## Addendum Number 02

Project: 3916.00 Dorothea Dix Building H Park Lot Design  
March 21, 2014

**Dorothea Dix Building H Parking Lot Improvements**

SCALE:	1"=20'
WBRC CAD FILE:	391600-C501
PROJECT No.	3916.00
JOB CAP/DRAW:	TAR
PM:	ARB
CHECKED BY:	ARB
DATE:	03.21.14
SHEET No.	ADD2-CP101

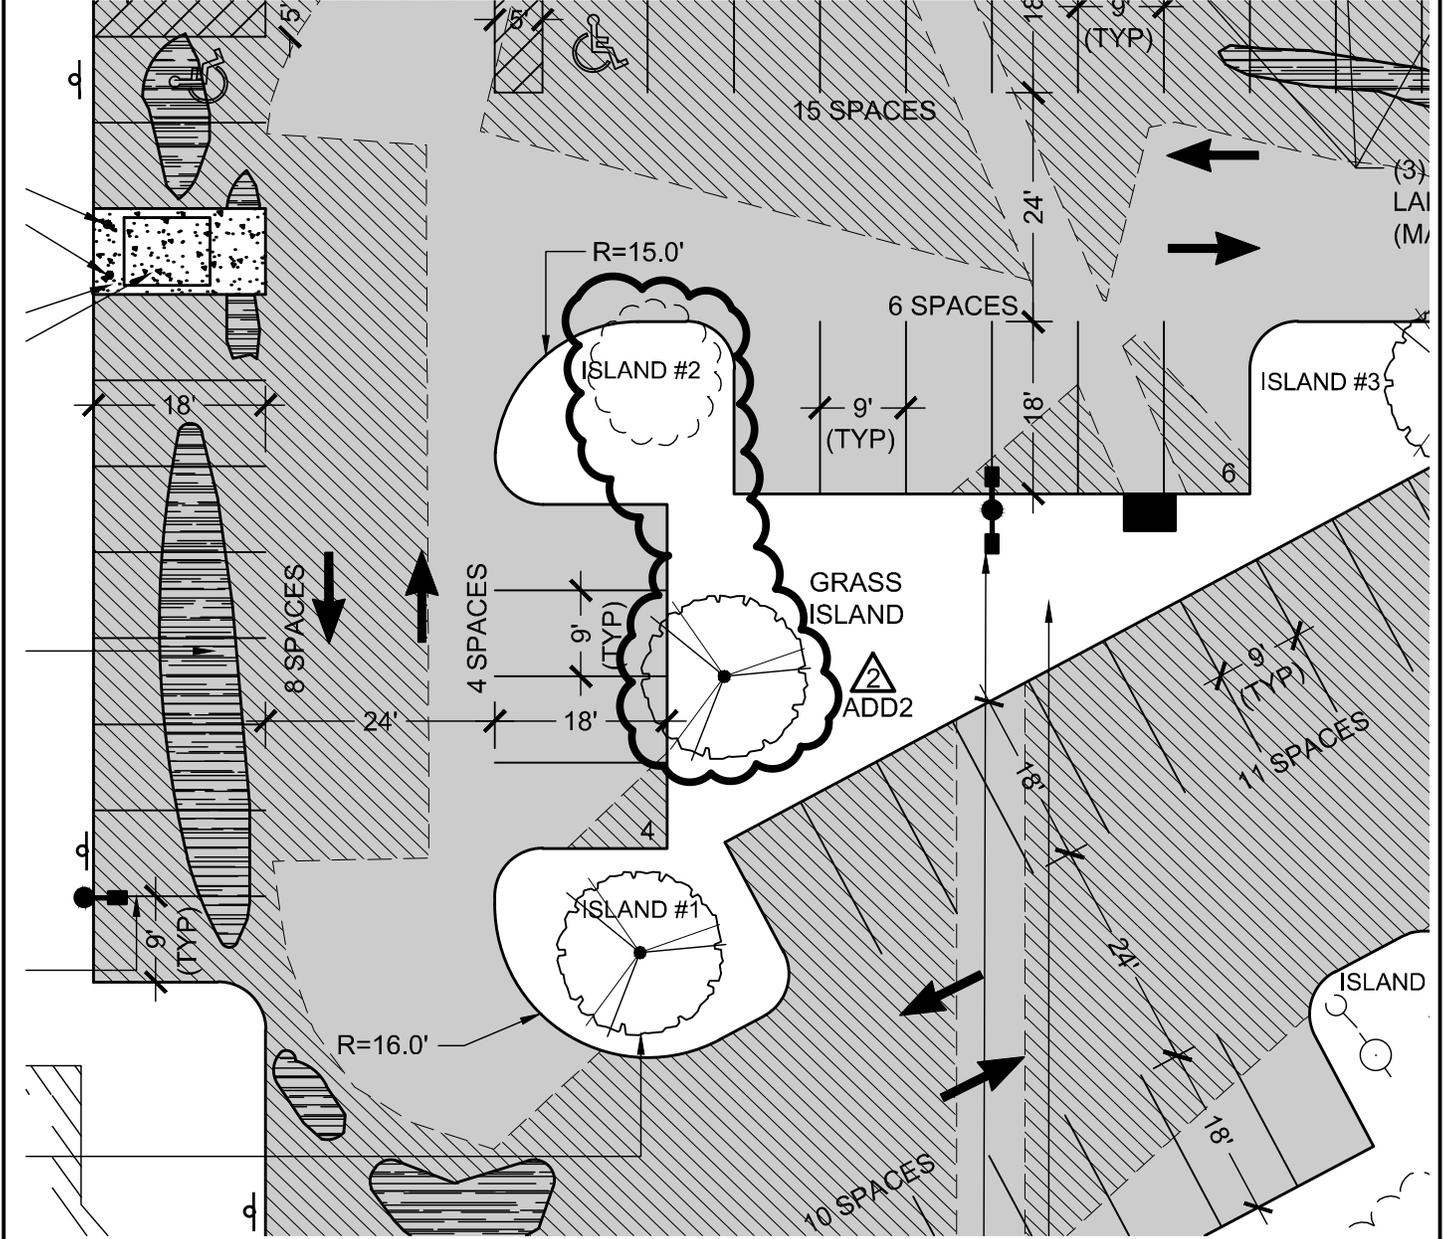
6. Sheet CD101, Site Removals Plan, DELETE sheet and REPLACE with attached sheet.
7. Sheet CP101, Site Layout & Materials Plan, REVISE portions as indicated on Sketch ADD2-CP101.
8. Sheet C503, Site Details, REVISE portions as indicated on Sketch ADD2-C503.
9. Sheet C504, Site Details, REVISE portions as indicated on Sketch ADD2-C504.
